SERVICE BULLETIN

APPLICABILITY: 2017-18MY Impreza
 2018MY Crosstrek
 2018MY Legacy and Outback
 2018MY BRZ

NUMBER: 15-211-17R
DATE: 06/13/17
REVISED: 07/25/18

SUBJECT: Reprogramming File Availability for Additional Optimization of Harman Gen 3 Audio and Navigation Head Units

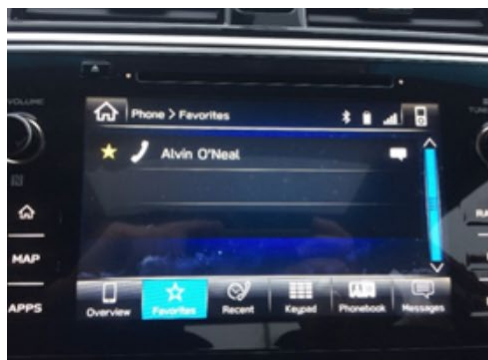
- Corrects for condition where only the star field background is displayed (without icons) after the HOME button is pressed.

Background shown, but no icons

Normal HOME screen with icons

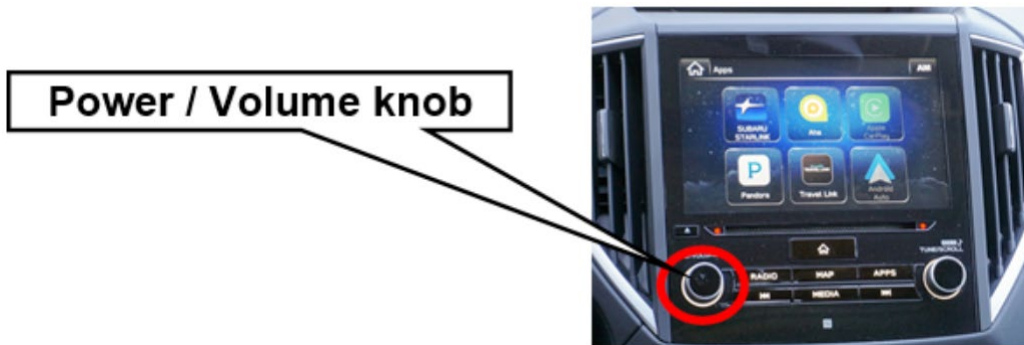
- Corrects for a “Pop” or “Crackling“ sound concern when listening to AM radio.
- Corrects for a concern of the head unit continually resetting itself.
- Corrects for a concern of after selecting a contact to be a “Favorite” and the “Favorite” list display is blank.

List is blank

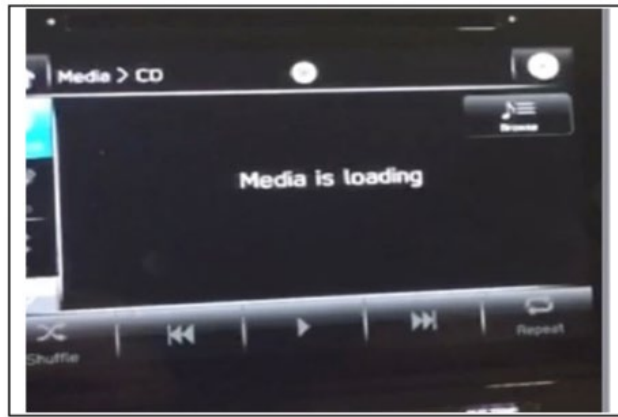
- An enhancement of Voice Recognition feature has been made for improved HVAC system interface and recognition of temperatures requested in Fahrenheit instead of Celsius. **EXAMPLE:** “Set temperature to 75.” With the previous version, the system interpreted “75” as degrees Celsius which would have been 167 degrees Fahrenheit and outside system parameters. As a result, there was no response from the HVAC system.
